City of Ketchum

December 2, 2019

(1) hear from the applicant and staff on PEG's updated plans, (2) hold a public hearing and receive public testimony on new information, (3) deliberate on the planned unit development CUP, and (4) continue the preliminary plat and development agreement portions of the public hearing

Applicant for Planned Unit Development Conditional Use Permit FILE NO. **P19-063** FINDINGS OF FACT, CONCLUSIONS OF LAW, ORDER OF DECISION OF THE CITY COUNCIL

CIVIL PLAN - RIVER STREET ENCROACHMENT - OPTION 1

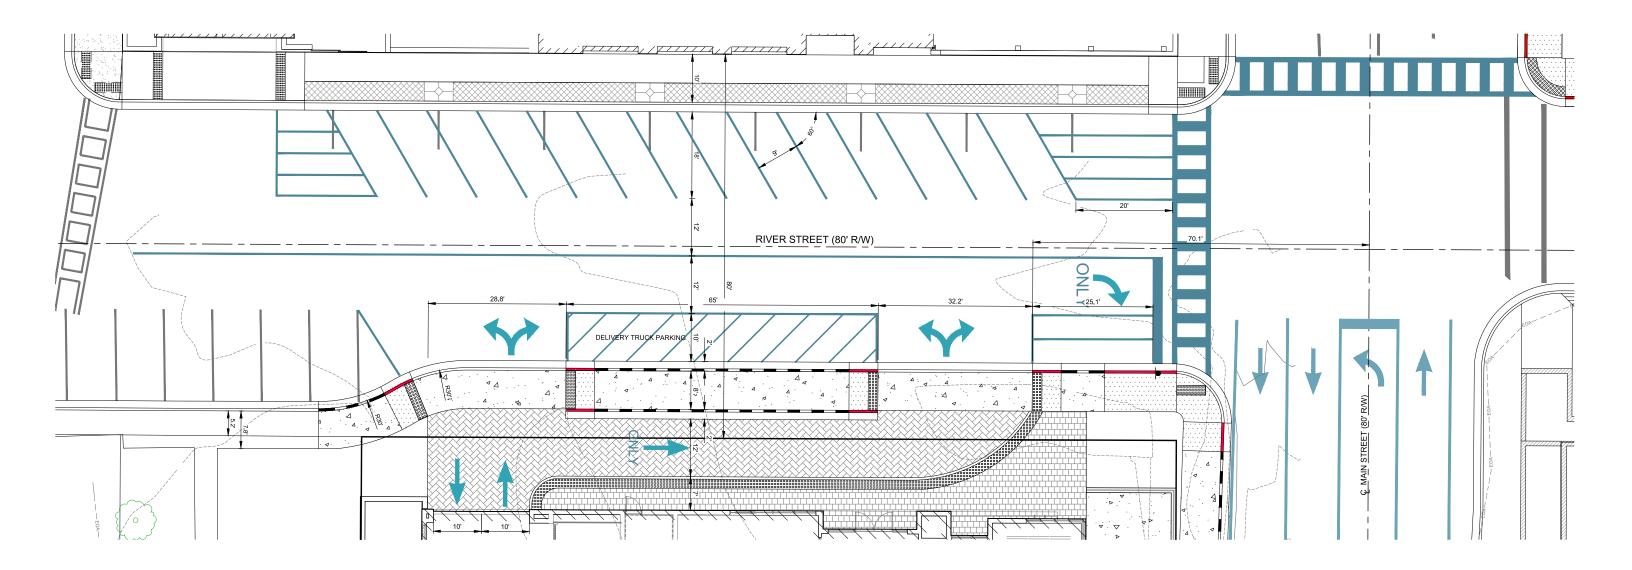
Planning staff recommends that the Council direct staff to work with the Applicant on Option 1 for the reasons highlighted below. Notably, Option 1 features the opportunity to create a public plaza space as recommended in the 2007 Gateway Scale & Massing Study. Option 1 is also preferred for purposes of walkability and for helping to anchor and activate this edge of the city's downtown. Option 1 is designed with snowmelt up to the curb line in a manner that fully accommodates city street plowing of snow. Furthermore, the offset of public parking spaces in the hotel parking garage, under terms defined by the KCC in the project development agreement, will assure public benefit.

SH75 INGRESS / EGRESS DIAGRAM

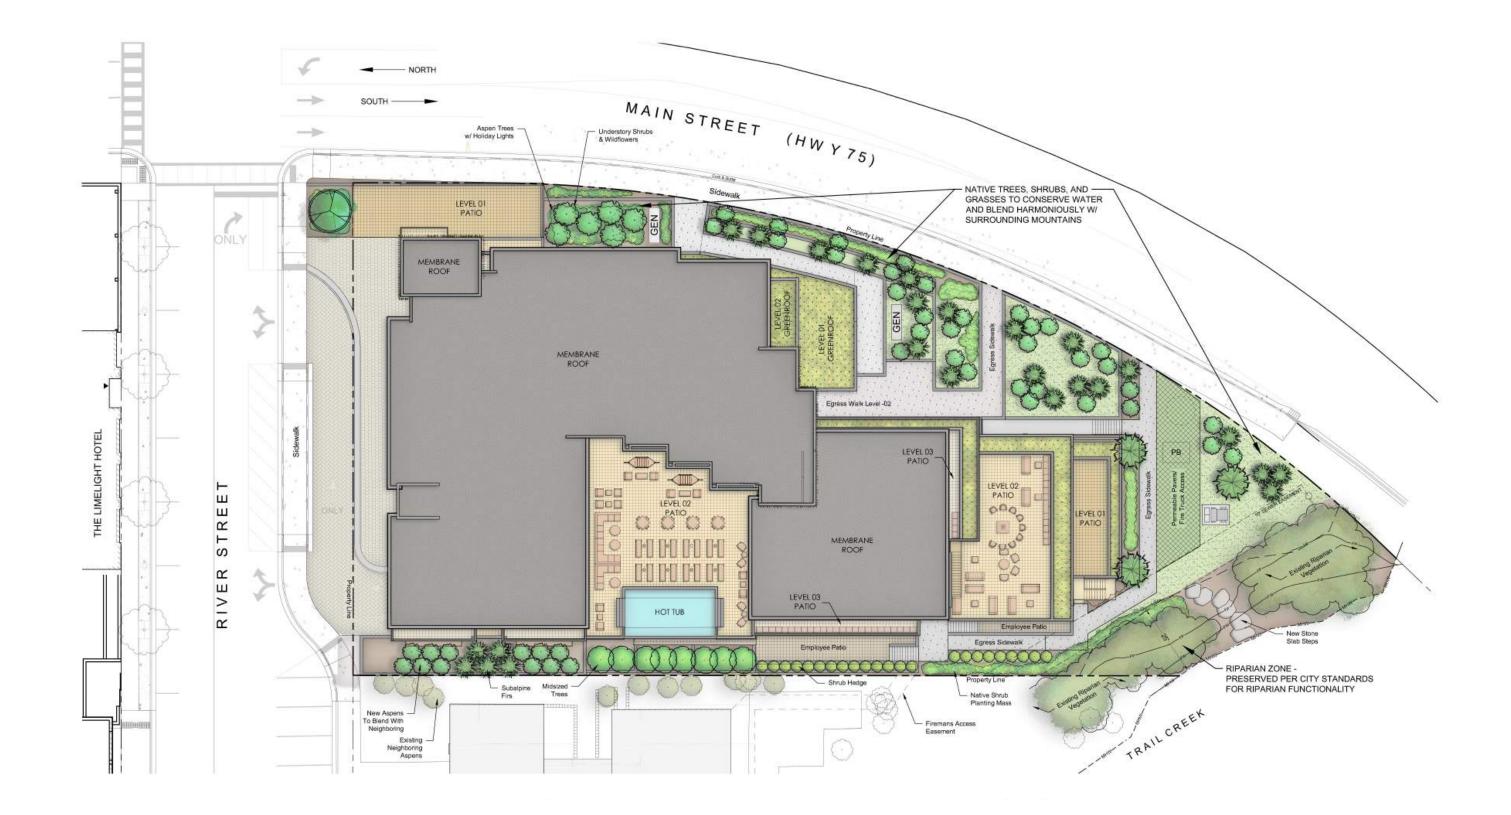
INADEQUATE SIGHT DISTANCE FOR MAIN STREET ACCESS CONGESTED WITH MERGING TRAFFIC

ajc architects has been asked by Ketchum City staff to study the impacts of creating a secondary delivery / loading dock entrance along SH-75 adjacent to the Trail Creek Bridge. This request came in response to inquiries made during an October 7, 2019 Ketchum City Council hearing to look at the feasibility and desirability of a truck drop-off on the south east elevation of the project. The design team has overlaid a typical truck turning radius onto the site and concluded that this option is not feasible for several reasons.

The development team has provided a concept which would require two access points to create a one-way directional drive. This concept would not be allowed based on IDAPA code. Furthermore, based on reviewing the developer's proposed site plan, significant grade drops and cross slopes would be required for the access and significant retaining walls would be required.

Hales also reviewed required intersection sight distance for an access on SH-75. Hales concluded that nearly 300 feet of sight distance to the north would be required for an exiting right-turn movement. No graphic was provided illustrating the feasibility of achieving this sight distance but given the curvature of SH-75 in this area, the sight plan would likely need to be altered to ensure a clear sight triangle along SH-75.

Please see attached site plan overlay and additional memo from Hales Engineering recommending no vehicular site access along Main Street / SH-75. If you have questions regarding this memorandum and recommendation, please feel free to contact us.

RIVER STREET | NORTH SCHEMATIC ELEVATION ADJACENT TO APPROVED BARITEAU HOTEL

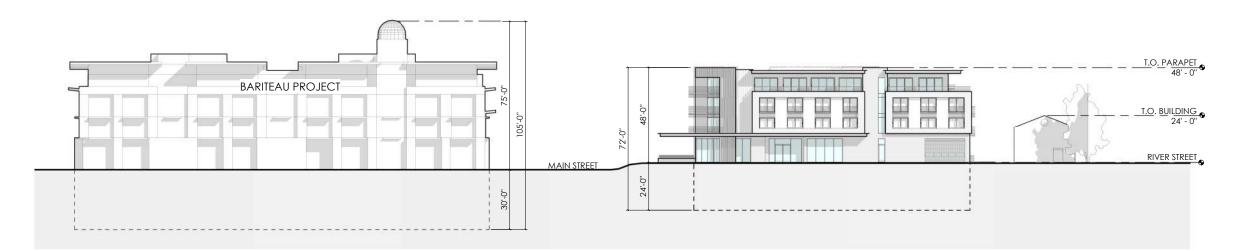
P&Z REQUESTED THE DESIGN TEAM STUDY BUILDING'S RELATIONSHIP TO ADJACENT PROPERTY.

CORNER ELEMENT

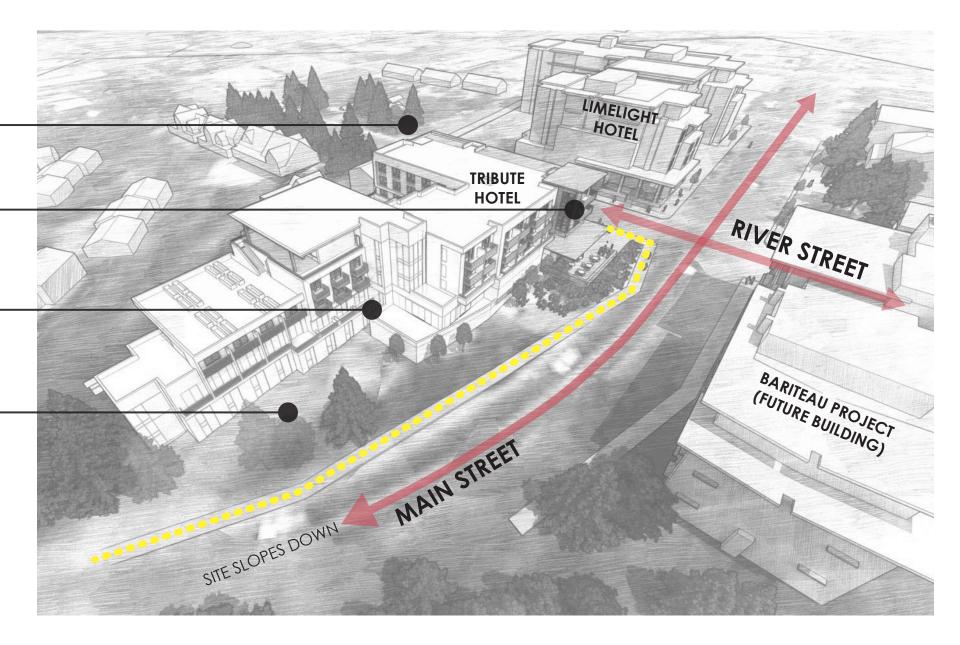
P&Z ASKED THE DESIGN TEAM TO SOFTEN THE ARCHITECTURAL PRESENCE OF THE CORNER ROOMS.

ADDITIONAL GLASS HAS BEEN ADDED TO THE CENTRAL STAIR CORE, ALONG WITH A LIGHT VERTICAL WOOD SCREEN TO SPLIT THE BUILDING MASSING
